# REVIEW OF US FILTER CORPORATION SALTON RIVER PROPOSAL FINAL REPORT

March 2003

**Salton Sea Authority**  
Plaza La Quinta  
78-401 Hwy 111, Suite T  
La Quinta, California 92253

**Tetra Tech, Inc.**

Fig. 4. BATHTUB-predicted water quality in the Salton River: (a) chlorophyll, (b) total N and (c) total P, comparing 1<sup>st</sup> and 2<sup>nd</sup> order nutrient sedimentation models.

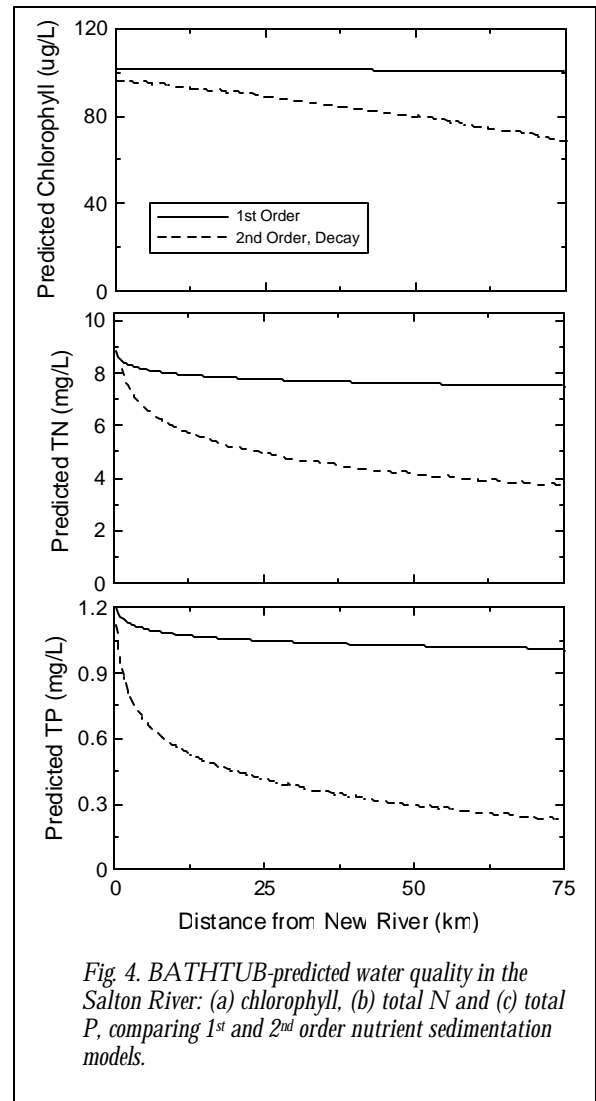
To help assess probable water quality in the Salton River, the BATHTUB model was used. Specifically, the west branch of the Salton River was simulated as a series of 5 identical, hydraulically-linked segments with an average width of 0.68 km, length of 15.1 km and average depth of 1.8 m. The 1<sup>st</sup> segment was fed by a flow of 898 cfs with a water chemistry equivalent to that reported by Holdren (2000) for the New River (*e.g.*, TN, inorganic N, TP and SRP concentrations of 8.20, 7.27, 1.11 and 0.70 mg/L, respectively). Nutrient sedimentation processes were represented using both the 2<sup>nd</sup>-order decay model and the 1<sup>st</sup>-order model, while chlorophyll was predicted using the P, N, light-model. The default model parameters were used for the simulations. It should be noted that internal loading and resuspension processes were not included in the model simulations, however.

The simulations indicate that the predicted water quality across the reach is strongly dependent upon the choice of model used to represent net particle settling (Fig. 4). Total P was predicted to decrease from 1.11 to 0.22 mg/L at the northern end of the Salton River (~75 km downstream) using the 2<sup>nd</sup>-order model, but to only 0.99 mg/L using the 1<sup>st</sup>-order model (Fig. 4). Total N was predicted to decrease from 8.2 to 3.55 or 7.39 mg/L depending upon sedimentation model (Fig. 4). Irrespective of the model used, high chlorophyll concentrations are expected across the entire length of the Salton River, with annual average chlorophyll concentrations of 72 – 100 µg/L. This compares typical chlorophyll concentrations of 30 µg/L and TN and TP concentrations of 3.80 and 0.065 µg/L presently in the Sea (Anderson and Amrhein, 2002). Thus, it seems clear that the claim by USFilter that “the Salton River would have lower levels of salt, nitrates and phosphates than the current Salton Sea” is not completely correct. While the Salton River would have a lower level of salt, it is likely that the River would, in fact, have *higher* levels of nitrates and phosphates than the Sea. Even with appreciable sedimentation losses, sufficient nutrients will be available to maintain a very high population of phytoplankton in the Salton River. Predicted Secchi depths averaged 0.3 m for the 1<sup>st</sup>-order model and 0.4 m for the 2<sup>nd</sup>-order model. Irrespective of resuspension effects, this high amount of algal turbidity will pose a substantial challenge to reverse-osmosis membranes without substantial pretreatment.
